CITY PLANNING COMMISSION
 1231 "I" STREET, SUITE 200, SACRAMENTO, CA 95814

APPLICATION:

B. Special Permit to exceed the 25% office use allowed by converting 8,000± square feet of warehouse to office and by adding 1,200± square feet of additional office space to an existing 26,300± square feet of office space located in four buildings on 4.5± developed acres in the Heavy Industrial (M-2S) zone.

LOCATION: 8401 Jackson Road

EXHIBIT A SITE PLAN

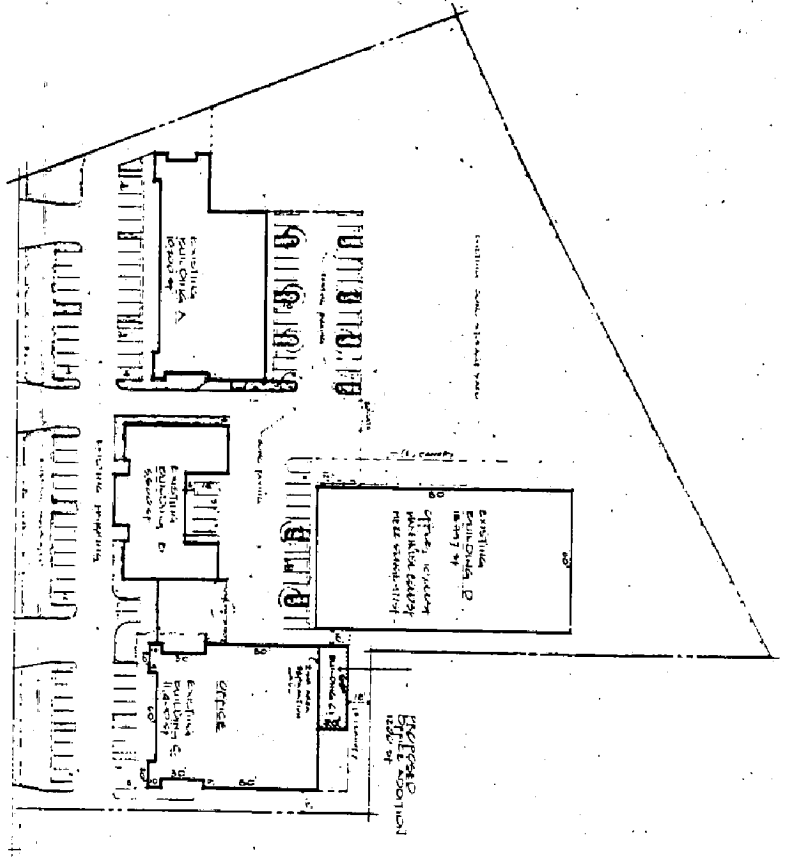
All required improvements on the site are existing. The applicant proposes to modify the existing site plan by adding a 60' X 20' addition to the rear of Building C. The addition will place Building C 10 feet from Building D (Exhibit A). No door openings are proposed on the west elevation of the proposed addition. The addition will not encroach into any setback or parking areas. All other modifications to this site will be interior tenant improvements.

The submitted site plan does not indicate the location of a trash enclosure. Trash dumpsters located outside the buildings will be required to meet the Zoning Ordinance requirements for trash enclosures.

The submitted plans indicate 104 parking spaces. The proposed use requires 101 parking spaces. Adequate parking is provided on site to accommodate the office and warehouse development of the entire site. The plans do not indicate any bicycle parking. Staff recommends that seven bicycle parking spaces (1:15 parking spaces) be added to the site due to the shift from warehouse to office use. The site is within 400+ feet of the College Greens Light Rail Station. Access to the light rail station is not provided from the site. The people using the light rail station will be required to around the adjacent site to the light rail station located on Folsom Boulevard. Staff recommends vanpools to the light rail station. Implementation of a Transportation Management Plan (TMP) will be required prior to issuance of building permits. Trip reduction measures such as transit passes, carpool/vanpool and showers and lockers on the site may be required. Processing time for approval of a TMP may take up to 60 days. Therefore it is advisable that the applicant obtain the necessary TSM processing application in advance of the building permit.

- 1. A Transportation Management Plan (TSM) shall be submitted for the review and approval of the City's TSM Coordinator prior to issuance of building permits.
- 2. A minimum of seven bicycle parking spaces shall be provided subject to the requirements of the Zoning Ordinance.
- 3. Trash dumpsters located outside the buildings shall meet the Zoning Ordinance requirements for trash enclosures.
- 4. The office use for which this special permit is granted shall be established within two years from date of approval. If the office is not so established the special permit shall expire. A special permit time extension for one year may be requested, in writing, 30 days prior to expiration.
